CITY OF ALLENTOWN

**R71 – 2019**

**Certificates of Appropriateness for work in the Historic Districts:  
130 N 15<sup>th</sup> St., 621 Gordon St.**

**HISTORIC ARCHITECTURAL REVIEW BOARD  
CITY OF ALLENTOWN, PENNSYLVANIA  
September 5, 2019  
FINAL REVIEW**

621 Gordon Street

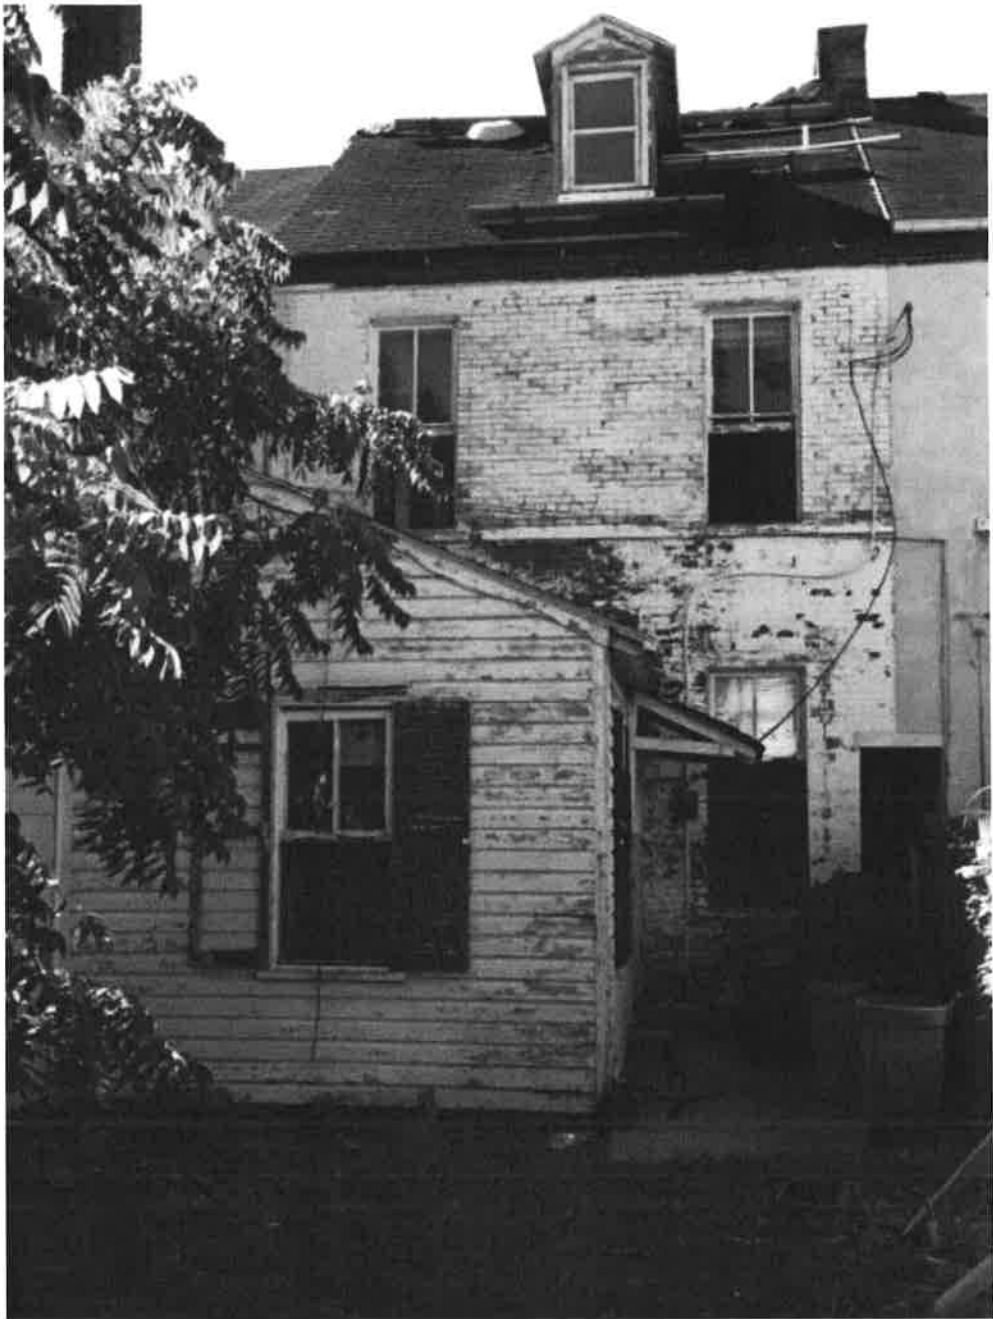
**Evaluation, effect on historic district, recommendations:** (First, a request to the applicant to make a concise list of work affecting the exterior of the building that needs HARB review on any future submissions. The materials provided were not clear nor organized in an appropriate way to facilitate review and comments. There were several cases of conflicting specs.)

The approach should be, wherever possible, to retain original materials and repair. In particular I am concerned about removing and replacing the brick façade. To approve this the structural need must be documented. The repair and reinforcement of the facade with tie backs into the

existing floor system should be investigated if the brick is not stable. Otherwise, the brick appears in reasonable condition and only requires repointing with soft, lime-based mortar. All brick repair and repointing must follow Preservation Brief #2.

- Windows – if the existing wood windows are beyond repair, the windows must be replaced with aluminum clad wood windows with 2 over 2 SDL configuration. Windows at the rear of the property could be replaced with vinyl windows per the Design Guidelines

- Front door - The front door cannot be a pre-hung door. If the original door is gone or beyond repair a salvaged or new wood door should be hung in the historic frame. The new door should match the historic door seen in older photographs which was a ½ light door with lower panels.

- Rear door – there was conflicting information on proposed door. A smooth fiberglass door with half glass and lower panels would be historically appropriate at the rear of the building.

- Repair or replace front porch steps – Repair of the concrete steps is recommended if possible. In either case the steps should have bullnose treads.
- Power washing and repointing of rear façade – The removal of the paint on the rear façade should be considered optional. Power washing pressure must be limited to a maximum of 400 psi and brick repointing must follow the Secretary of the Interior's Standards and Preservation Brief #2 on the historic masonry. Both removing the paint and repainting the rear façade would be historically appropriate.

- Reconstruction of the rear 1 story addition walls – The walls and siding of the historic addition should be retained if possible. Investigate keeping existing stone foundation and cistern. Cistern could be infilled and capped, and new floor framed over it.

- Light fixture, mailbox and house numbers – These items should be reviewed at the staff level once cut sheets provided. The existing light fixture is historically appropriate and should be kept if possible. House numbers are located on the door frame and could be retained. A door slot for mail should be considered instead of a mailbox.

- a. New front windows will be 2/2 double hung aluminum clad wood with simulated divided lights. The windows will fit the existing openings exactly
  - b. The lintels over the windows that remain will be repaired. For windows where the lintels are missing, new lintels will be made that match the existing. (Contact information for a contractor who can replicate the lintels was provided to the applicants).

- c. New rear windows (including windows in the rear addition) will be fiberglass 2/2 double hung windows with simulated divided lights. The windows will fit the existing openings exactly or match historic size (addition)

- d. All wood trim and casings will be painted
  - e. A new or salvaged front door will be installed in the existing door frame. The door will be wood with half light and panels below

- f. A new smooth flush glazed fiberglass or wood door with half glass and panels will be installed in the newly reconstructed rear addition.
  - g. The rear addition will be reconstructed to match the existing in size, form, roof slope, and trim detail. Drawings of the rear addition must be submitted for staff review.

- h. The new siding on the rear addition will be smooth fiber-cement lap siding with a 4" reveal, cornerboards, and trim. Composite material shutters may be installed on the addition, but specification must be approved by staff.

- i. The front brick façade will be repaired and repointed following Preservation Brief #2 guidelines.
  - j. The rear painted brick will be power washed with low pressure (400 psi max), repointed following Preservation Brief #2 guidelines, and repainted. Removing paint from the rear brick is optional and must follow Preservation Brief guidelines.

- k. The front concrete steps will be repaired in kind with bull-nosed treads
  - l. The existing fence will be replaced with a new 6' high dog eared board fence with 42" wide x 72" high gate.

- m. The existing front light fixture will be reused if possible.
  - n. Existing reused or new address numbers will be installed on the front door frame

- o. A mail slot will be installed in the new front door instead of installing and wall mounted mailbox.

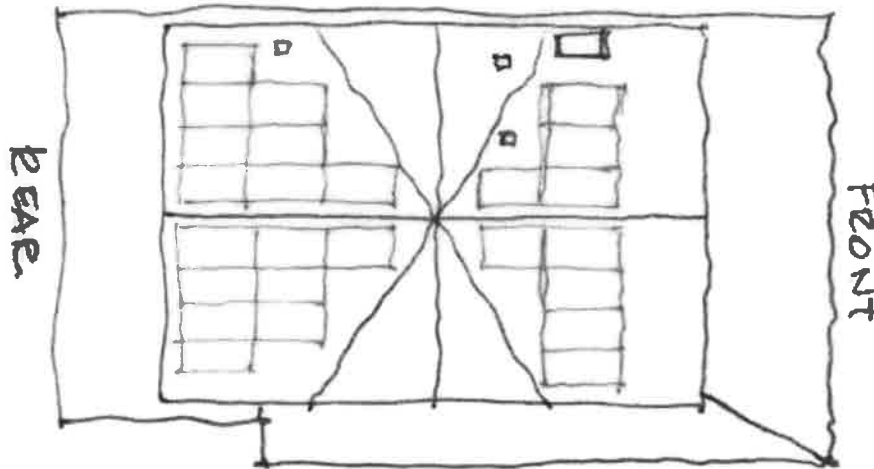
**Evaluation, effect on historic district, recommendations:** The solar panels are not historically appropriate as proposed (locations), but if repositioned, some or all of the units may be possible. From the guidelines: *"Sloped roof - On sloped roof structures, solar devices should be mounted on rear roofs that are part of secondary facades. The solar panels should be flush mounted on sloped roofs if possible".*

The upper roofs have a low slope and are not highly visible at the rear and only partially visible from the front. The Tesla solar panels are shown flush with the roof in image below. If flush to the roof and moved to the back gable and away from the front edge of the front roof, the installation would be close to meeting the design guidelines. (See sketch) The other modification that would reduce the visibility of the installation would be to replace the roof shingles with new shingles a dark gray color that blended with the color of the panels. below is an image of Tesla solar panels: Powerwall (interior installation assumed):

3. Seven panels will be moved from the front edge of the front "dormer" roof to the back roofs.
4. The solar panel installation is being approved on front roofs because of the following unique conditions:

- d. The solar panels are flat to the roof and are finished on the edges to blend into the roof surface
5. It is recommended that the edges of the solar panels be painted a brown color to match the roofing color.

6. The solar panels will start 10' back from the front of the house.
